REMARKS

DRAWINGS:

VERSION WITH MARKING TO SHOW CHANGES MADE

FIG.5

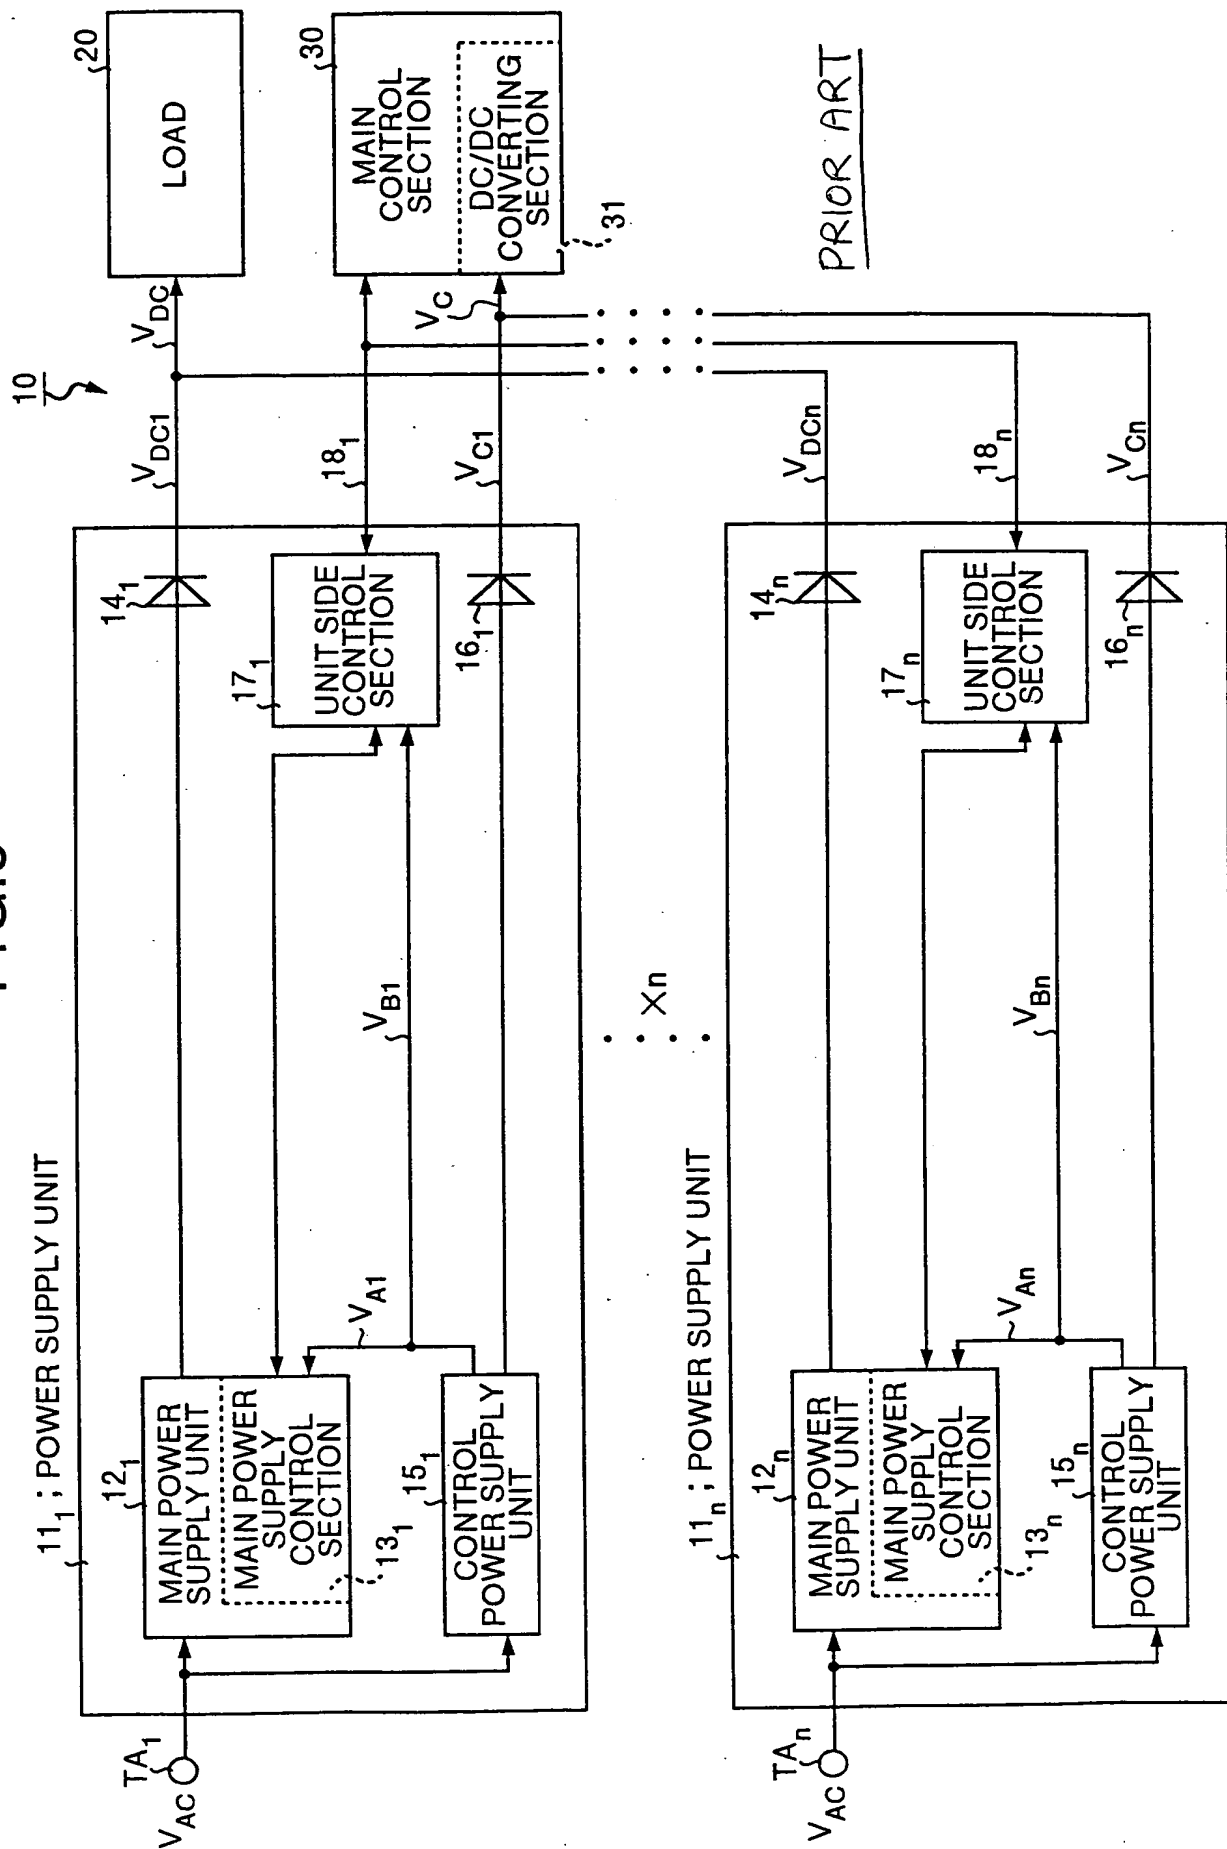
In the Office Action, at page 2, the drawings were objected to as set forth in MPEP § 608.02(g). The Examiner stated that FIGs. 5 and 6 should be designated by a legend such as -- Prior Art-- because only that which is old is illustrated. In the Letter to the Examiner Requesting Approval of the Changes to the Drawings being filed herewith, a copy of which is attached hereto, Applicant has made the requested designation for FIGs. 5 and 6 as shown in red. Also, for the Examiner's convenience, unmarked corrected FIGs. 5 and 6 are enclosed. Accordingly, it is respectfully requested that this objection be withdrawn.

PRIOR ART
